ADDENDUM NO. 1 TO BID FORMS

**CORONA-NORCO UNIFIED SCHOOL DISTRICT
PURCHASING DEPARTMENT
Bid No. 2023/24-204**

CORONA FUNDAMENTAL INTERMEDIATE SCHOOL MPR MODERNIZATION

COMPUTER LAB ROOM 2 - WEST 11
SCALE: 1/4" = 1'-0"

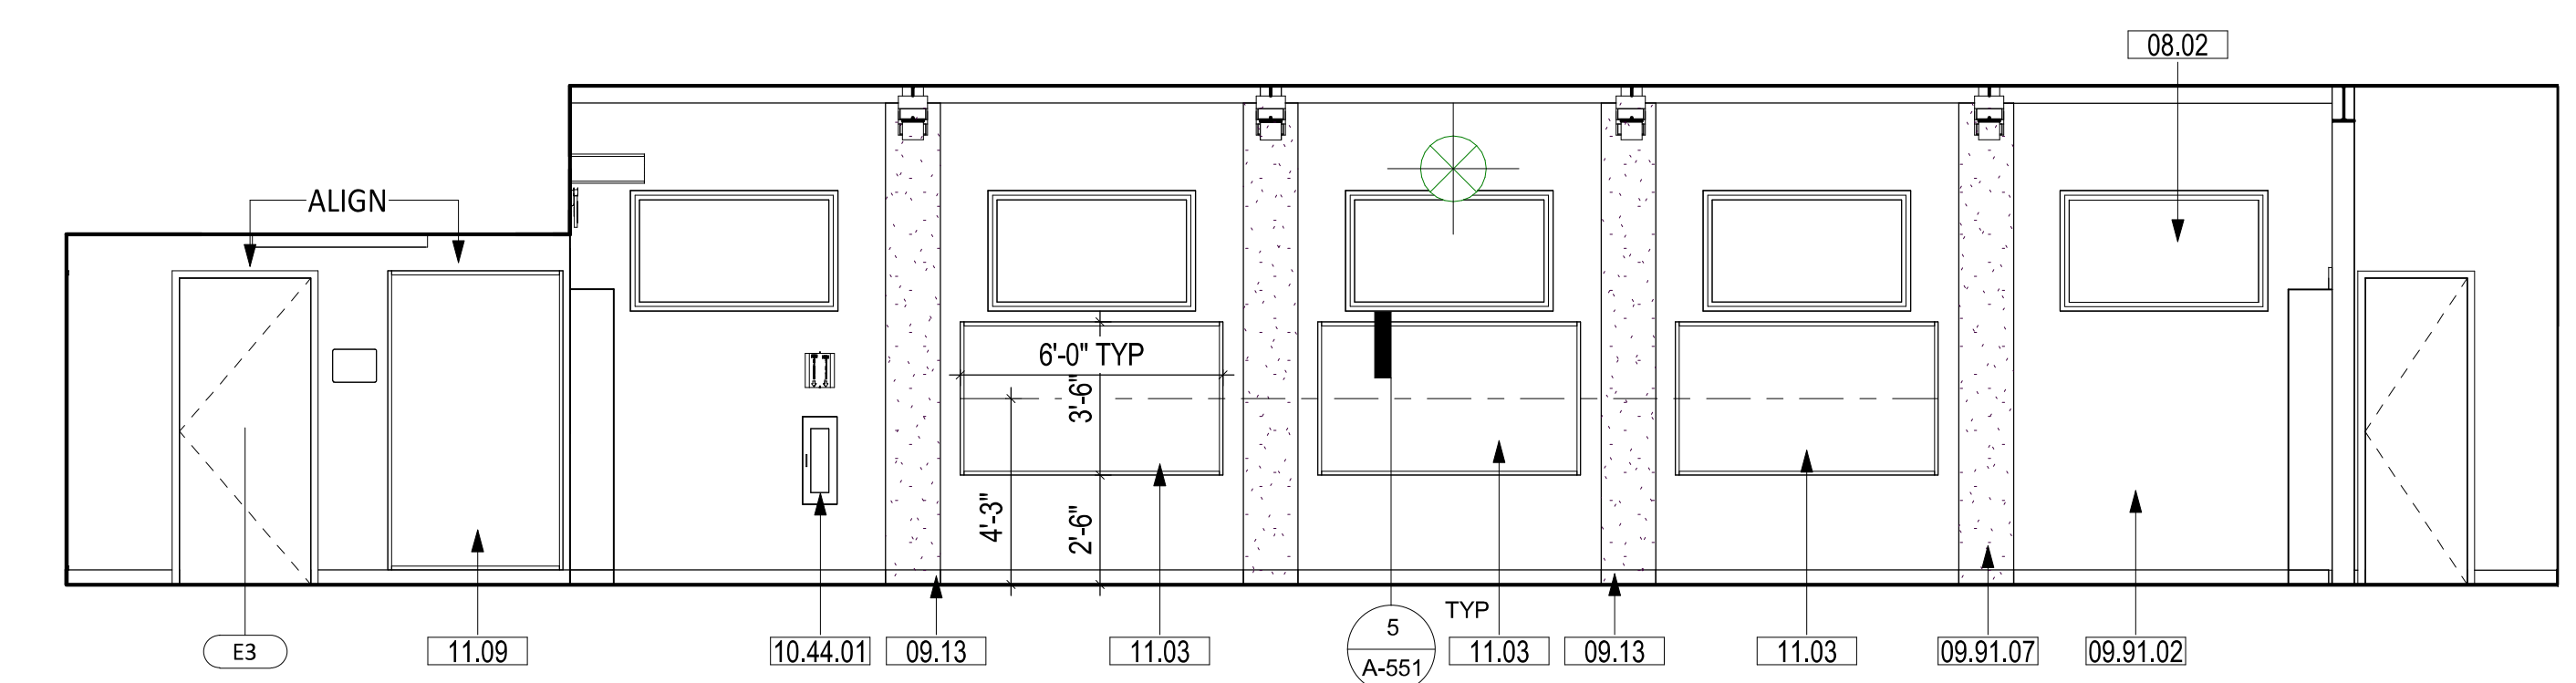
Item No. 1.05
Sheet A-411 - COMPUTER LAB ROOM 2 - ENLARGED PLAN & INTERIOR ELEVATIONS

- Girls' Toilet Room 9 layout revised
- Keynote 11.50 revised

SHEET NO.:
A-412

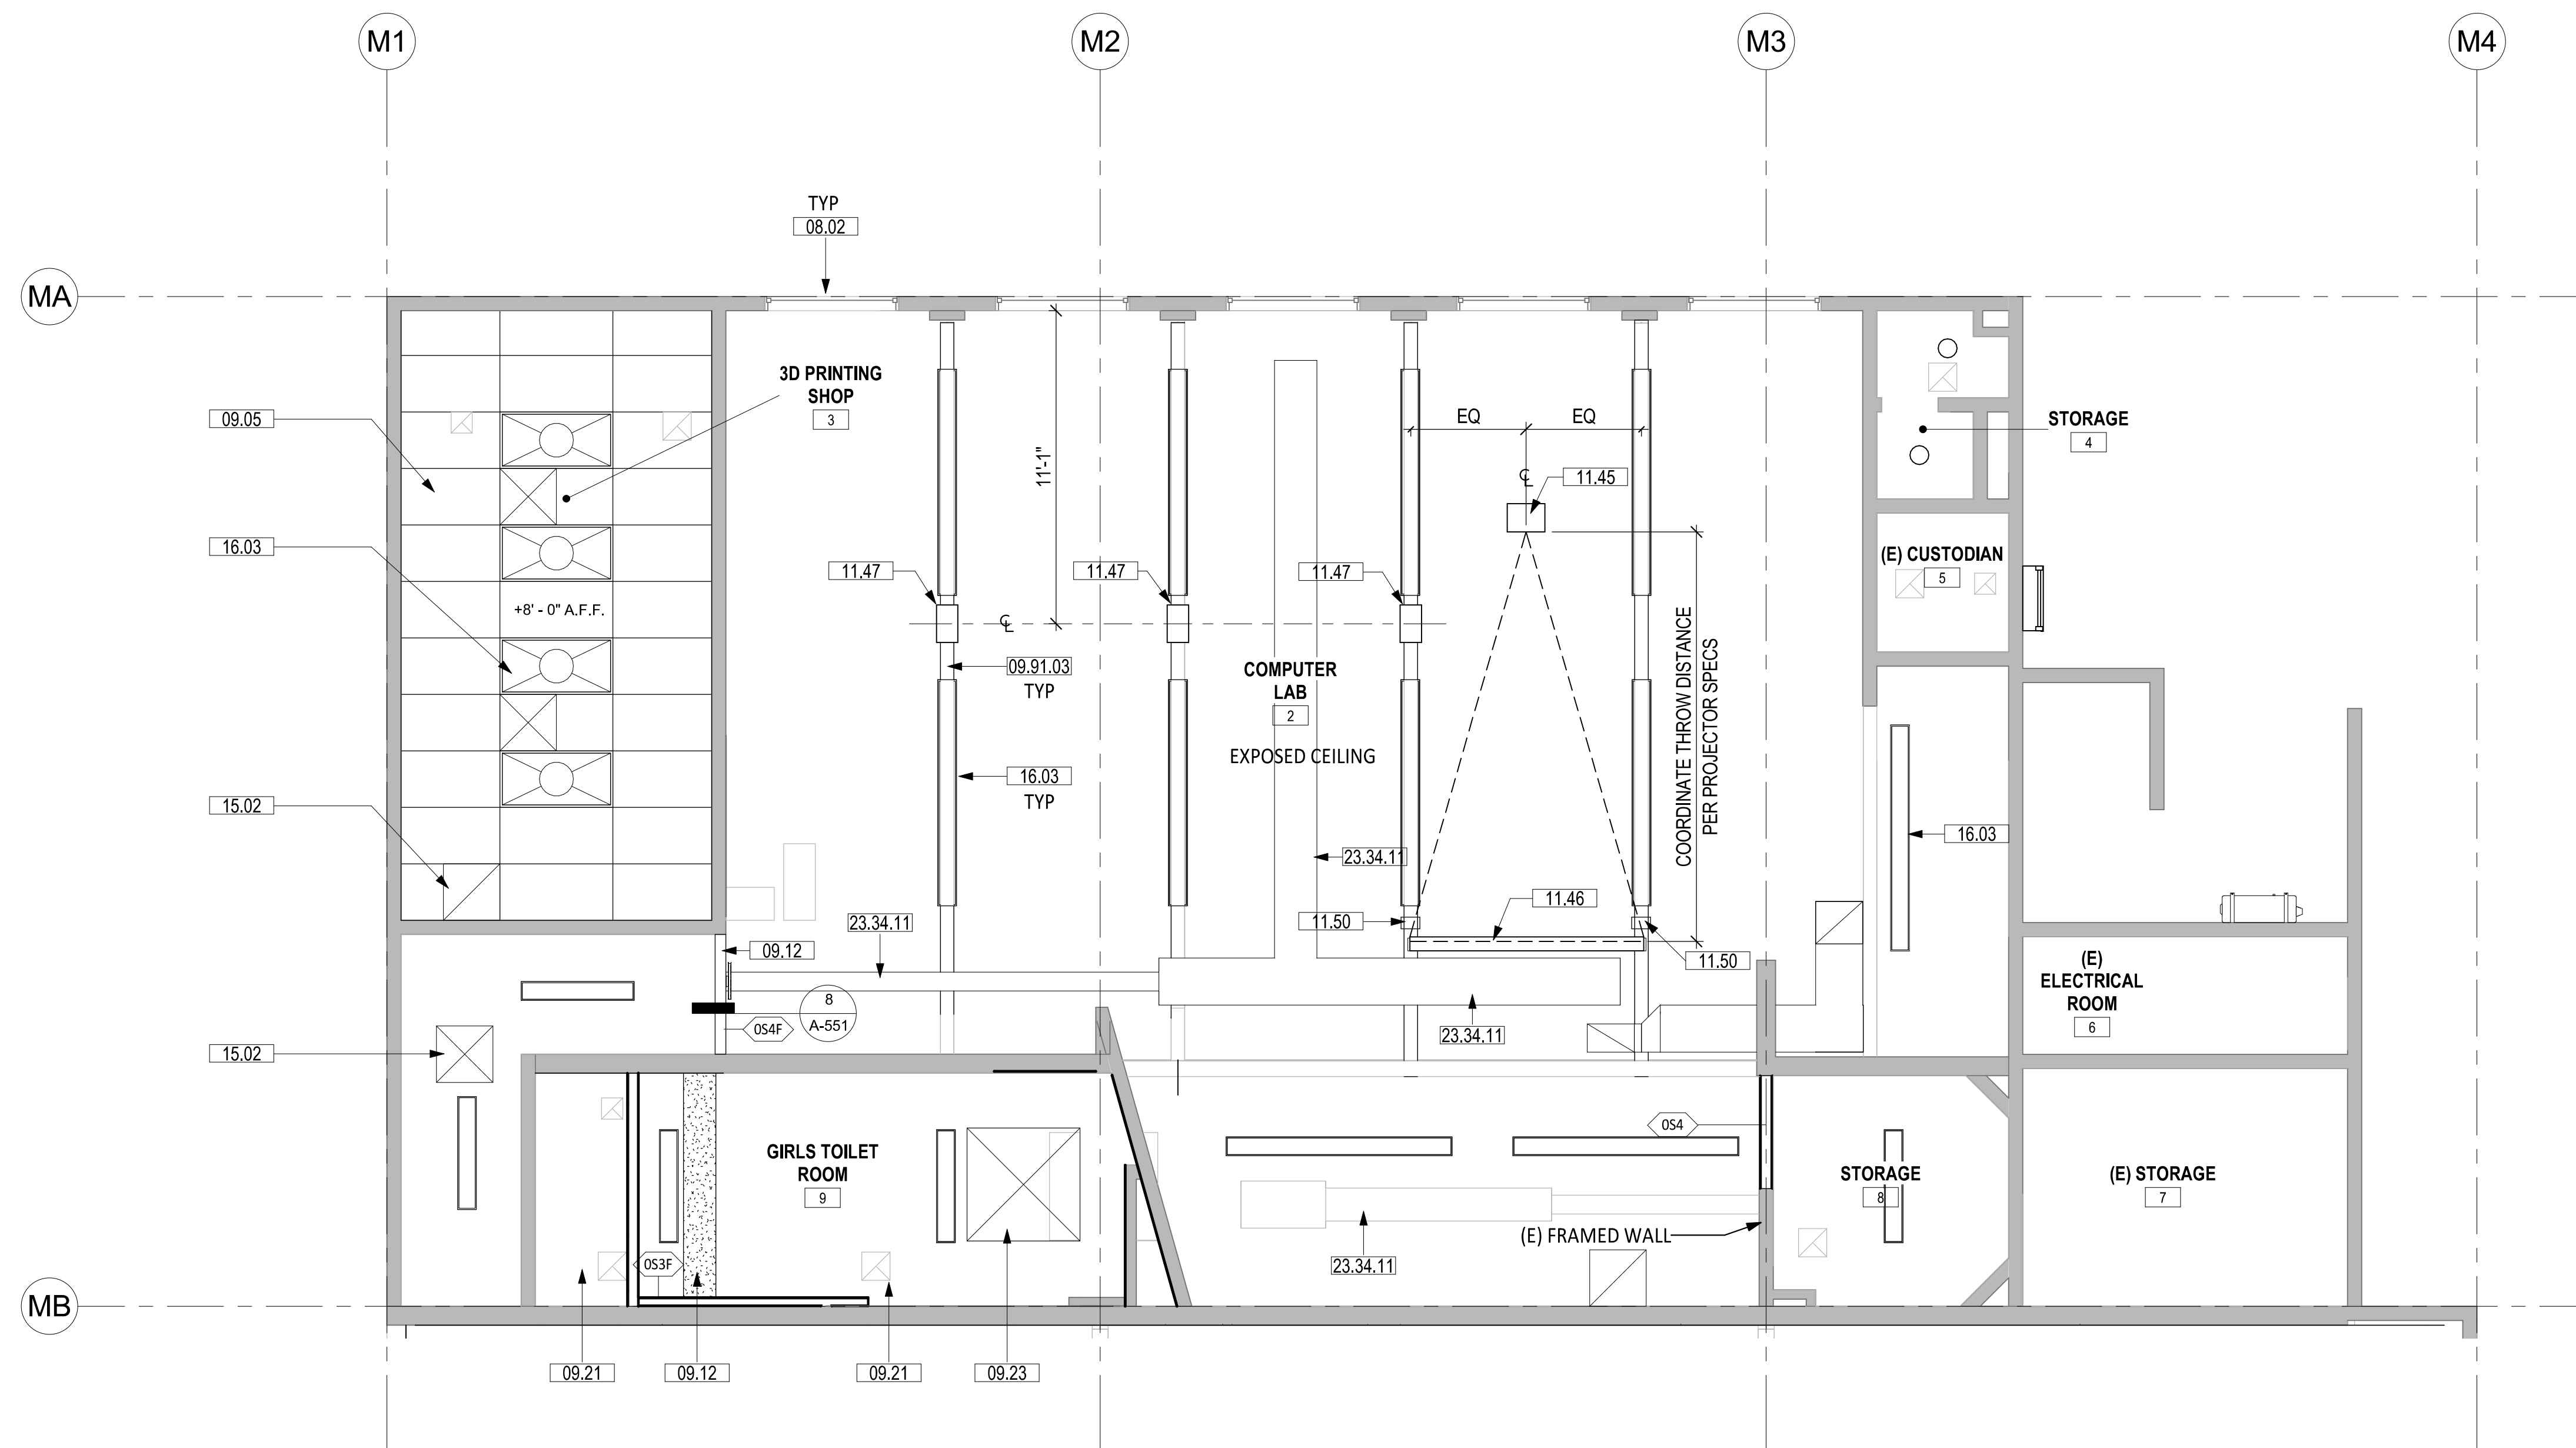
Item No. 1.06
Sheet A-412 - COMPUTER LAB ROOM 2 - ENLARGED RCP

- Added Sheet Note 5 for work on ceilings and walls

SHEET NO.: A-421

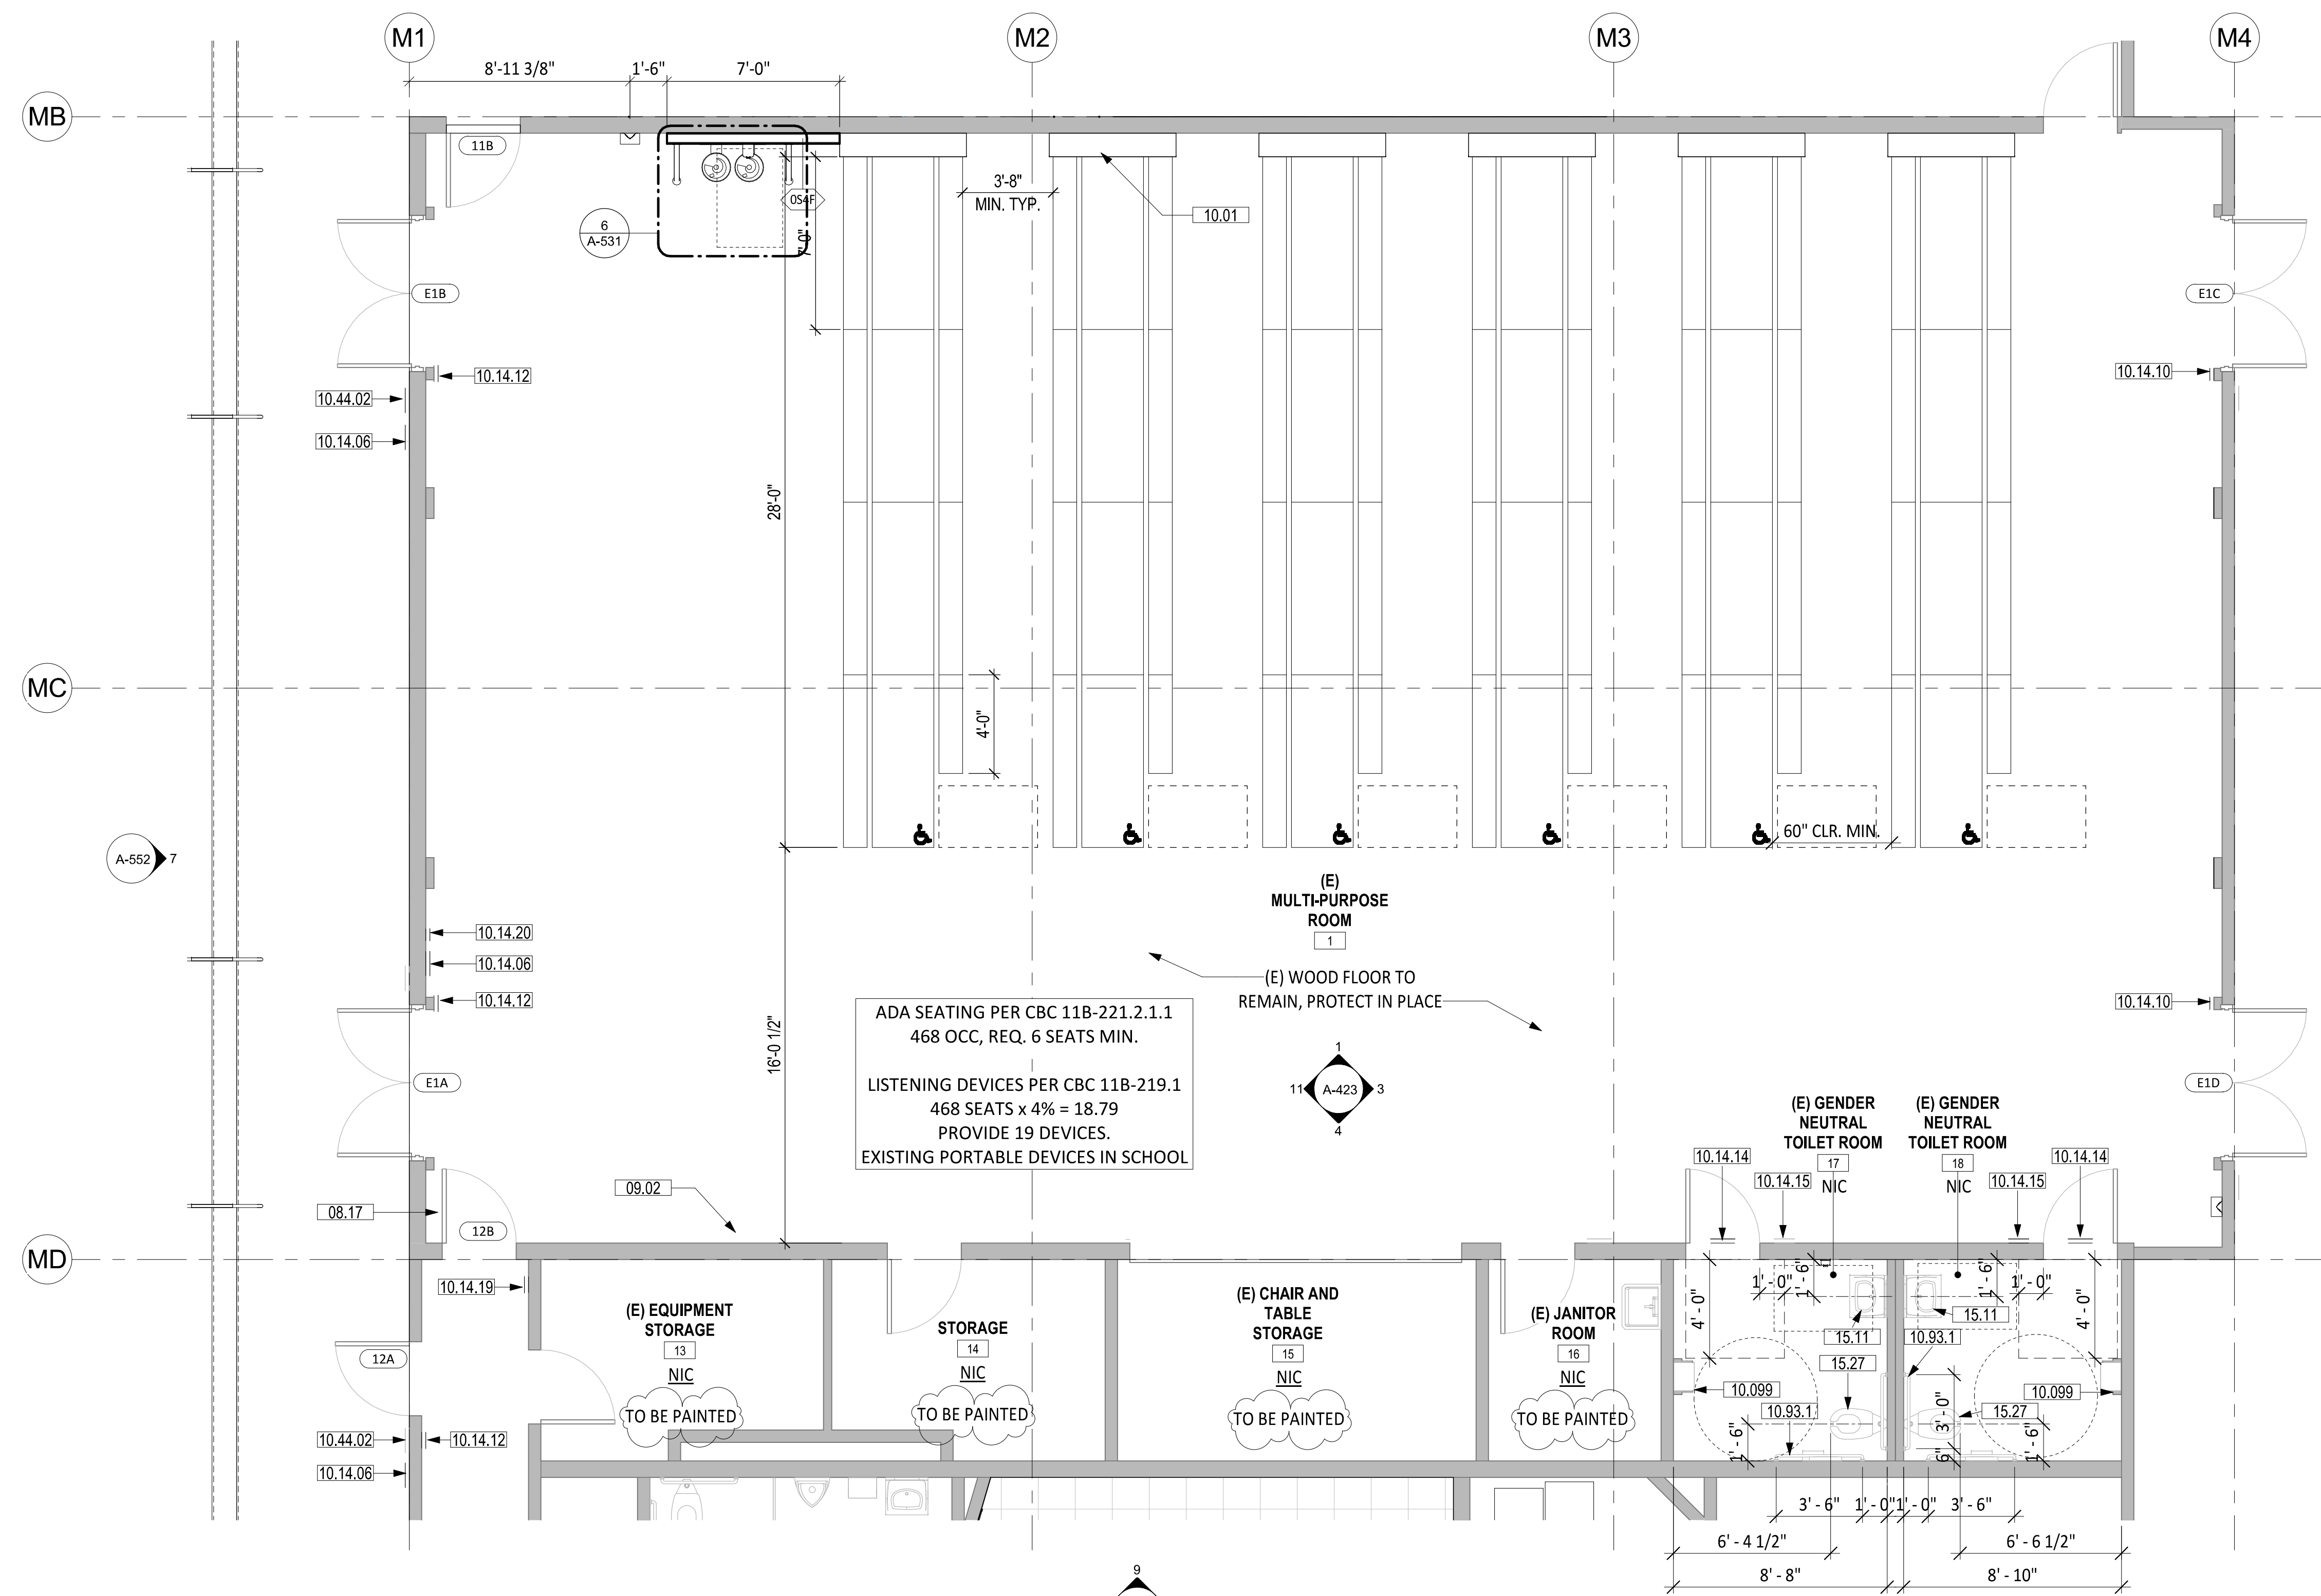
Item No. 1.07
Sheet A-421 - MPR - ENLARGED PLAN

- Added notes for rooms 13-16 to be painted
